ADDENDUM# 1

NEW RESTROOM AT EISENHOWER PARK

Bid # 200015

March 3, 2020

SK-1

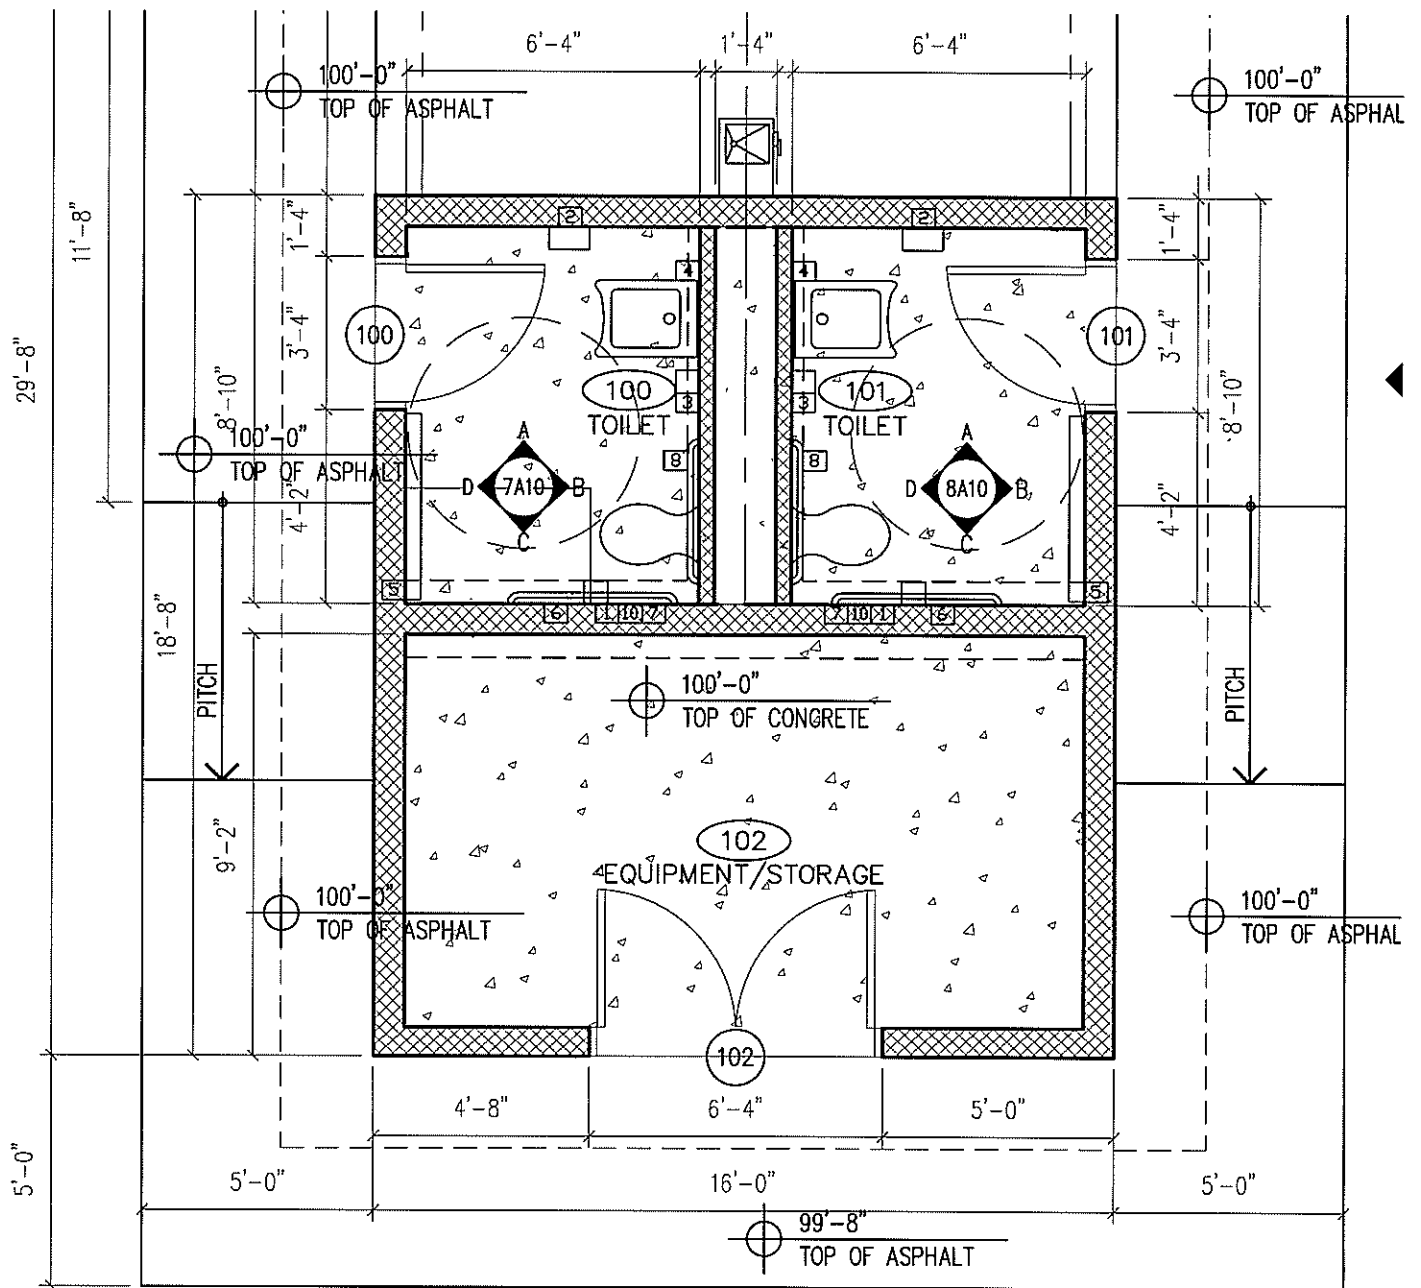
- Sketch of the revised chase wall construction with 4" CMU each side and the required 16" clear space.
- The PVC soffit material shall be fiber cement board.
- There is no FSC chain of custody for the wood on this project.
